# **UN Regulation No. 150**

## Retro-Reflective Devices (RRD)

**Main changes in Stage II**

**SLR-46-23**

## **Changes in the examples of the approval markings arrangement**

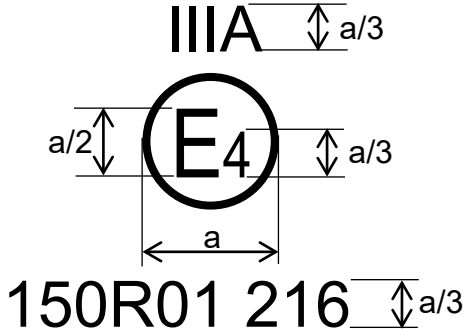
- Space removed for class IIIA
- Size aligned
- “104R” removed
- “27R” replaced by WT
